**Replace Wastewater Plant South Rim Village
GRCA-257282**

**100% Complete Construction Documents
Addendum 4**

September 8, 2026

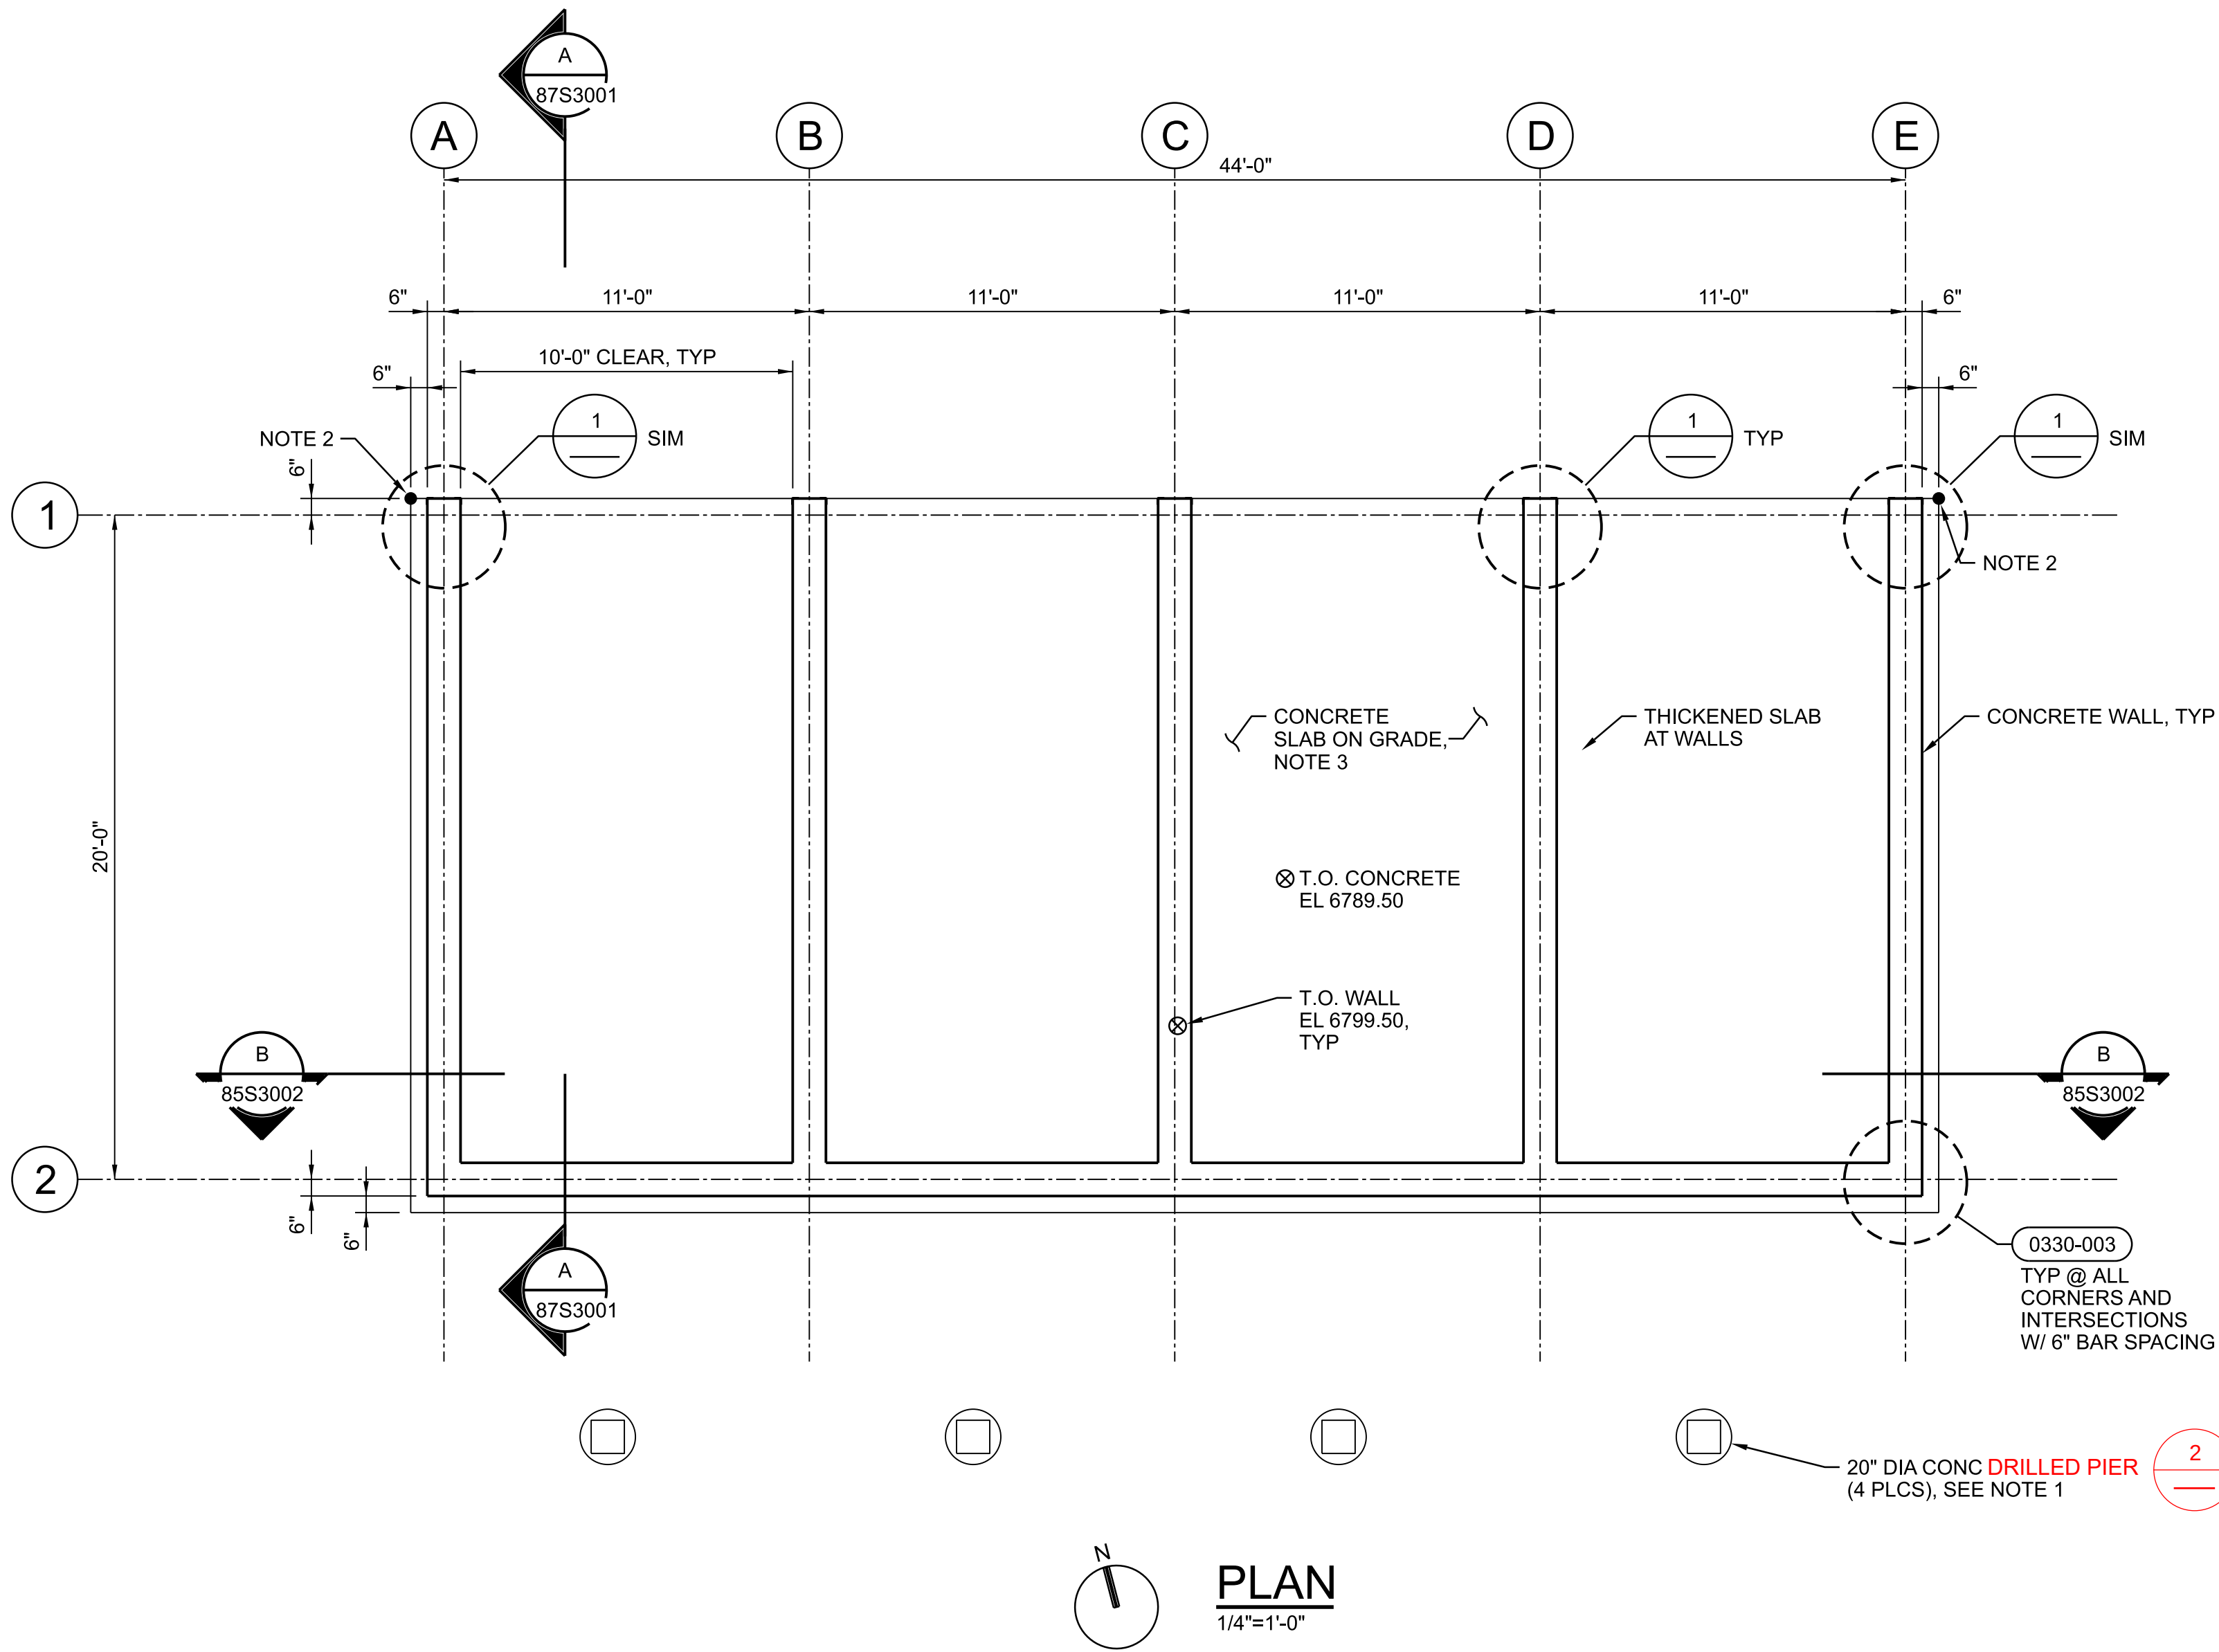
New or Updated	Sheet No.	DWG No.	Sheet Name	Description
Updated	391	87S1030	Compost Facility Structural Foundation Plan and Detail	Added Detail 2 for drilled pier reinforcement
Updated	361	80D3002	Digester Facility Mechanical Sections	Revised detail number and valve size
